**Subject: MHI's Responses to US-APWR DCD RAI No.103-1448 Revision 0**

Responses to Request for Additional Information No.103-1448  
Revision 0

**US-APWR Design Certification  
Mitsubishi Heavy Industries  
Docket No. 52-021**

**RAI NO.:** NO. 103-1448 REVISION 0  
**SRP SECTION:** 05.02.02 – Overpressure Protection  
**APPLICATION SECTION:** 5.2.2  
**DATE OF RAI ISSUE:** 11/20/2008

**Figure 5.2.2-2.1 Surge-Line Volumetric Flow Rate versus Time  
Loss of External Load/Turbine Trip Transient  
- without Reactor Trip**

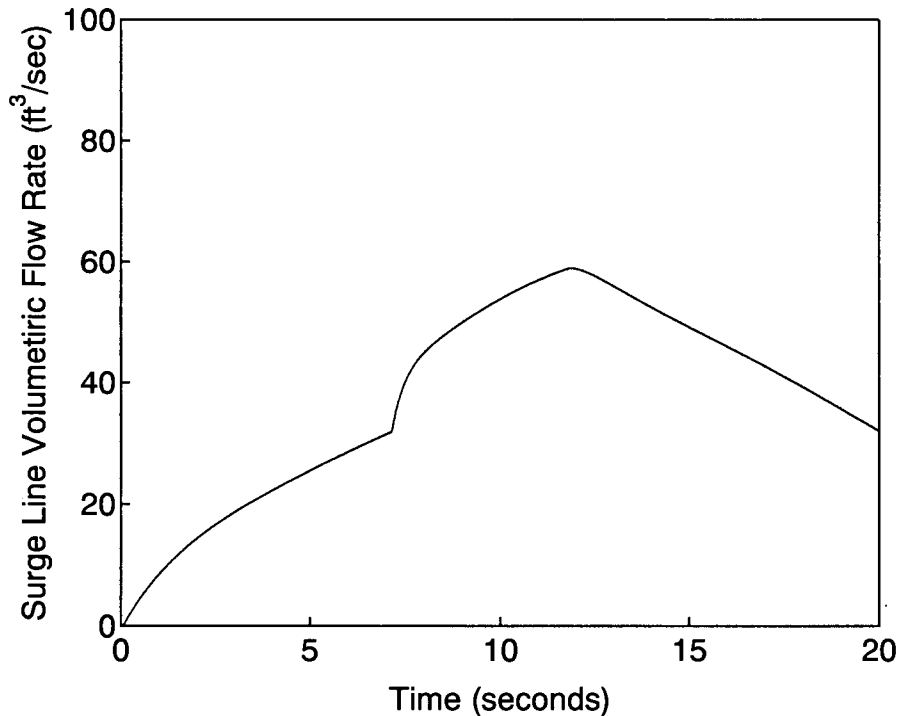
In section 5.2.2, the applicant stated that the "RCS and main steam system overpressure protection during power operation are provided by the pressurizer safety valves and the main steam safety valves, ..... Combinations of these systems provide compliance with the overpressure protection requirements of the ASME Boiler and Pressure Vessel Code...." Provide the references or documentation for the methodology, analysis, and results that support the applicant's position that the ASME criteria are satisfied as stated.

The results for the pressurizer safety valve sizing analysis are provided in Figure 5.2.2-2.1. Per DCD Section 5.2.2.1.1, the total pressurizer safety valve capacity is required to be at least as large as the maximum surge rate into the pressurizer during the analyzed transient. Figure 5.2.2-2.1 provides the calculated volumetric flow rate of the surge line for the loss of external load / turbine trip event assuming no reactor trip. Conservative assumptions are made in this analysis to maximize the pressurizer insurge.

This sizing methodology results in a pressurizer safety valve capacity in excess of the capacity required to prevent exceeding 110% of the RCS design pressure, ignoring the first reactor trip in accordance with ASME Pressure Vessel Code Paragraph NB-7311. This is done by assuring for the most limiting anticipated operational occurrence (loss of load) that the pressurizer steam space pressure does not exceed 103% of design pressure corresponding to the pressure when the safety valve is fully open. This pressurizer steam space pressure increase also considers piping downstream of the safety valve discharge. In addition, the pressure difference between the safety valve inlet and the highest pressure in the RCS is considered. This includes the pressure drop around the RCS piping, pressurizer surge line, and elevation heads in the RCS. The highest RCS pressure is at the reactor coolant pump discharge when the pumps are operating.

**Figure 1 Primary coolant pressure variation (mass input case)**

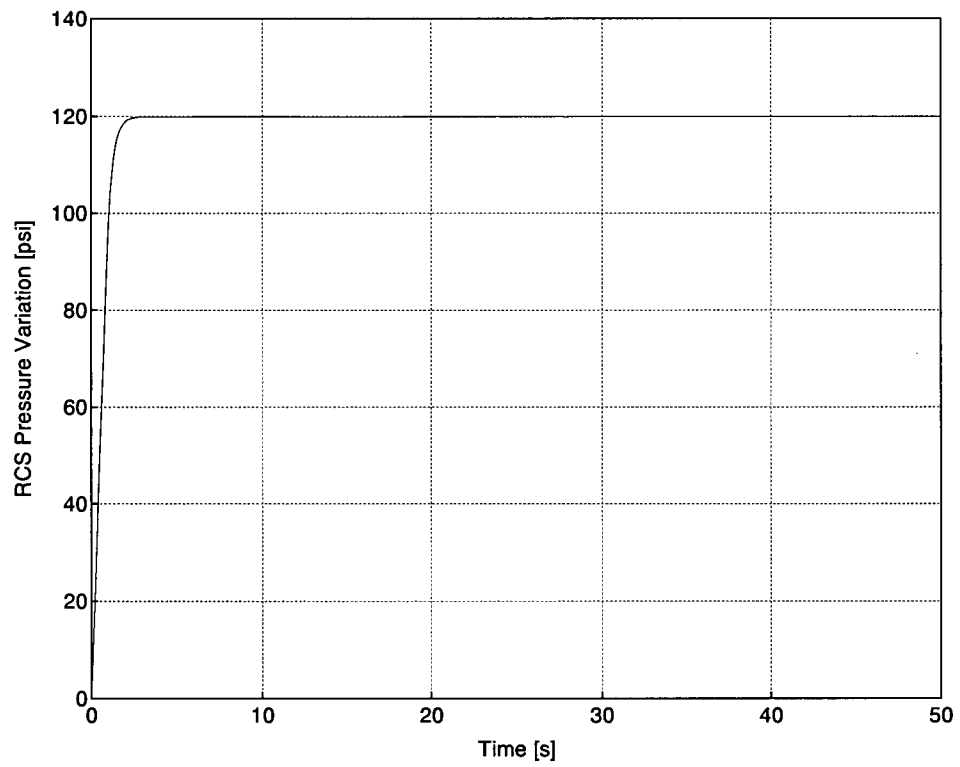
In Subsection 5.2.2.1.2, the applicant states that “the LTOP is designed to meet the following requirements” of Branch Technical Position (BTP) 5-2 which requires that the “...system is designed and installed to prevent exceeding the applicable technical specifications and Appendix G limits for the RCS while operating at low temperatures. The system is capable of relieving pressure during all anticipated over-pressurization events at a rate sufficient to satisfy the technical specification limits, particularly while the RCS is in a water-solid condition.” Provide the references related to the analysis or supporting documentation which demonstrates how the above requirements are satisfied.

Figure 1 is the plot of primary coolant pressure variation versus time for mass input case. Maximum primary coolant pressure variation is 120 psi.

From the results of analyses, the largest pressure variation is 120 psi (mass input case). As initial pressure condition is 400 psi, so the maximum pressure is 520 psi. This pressure is lower than the upper limit, approx 620 psi. therefore, LTOP system meets the Appendix G limits.
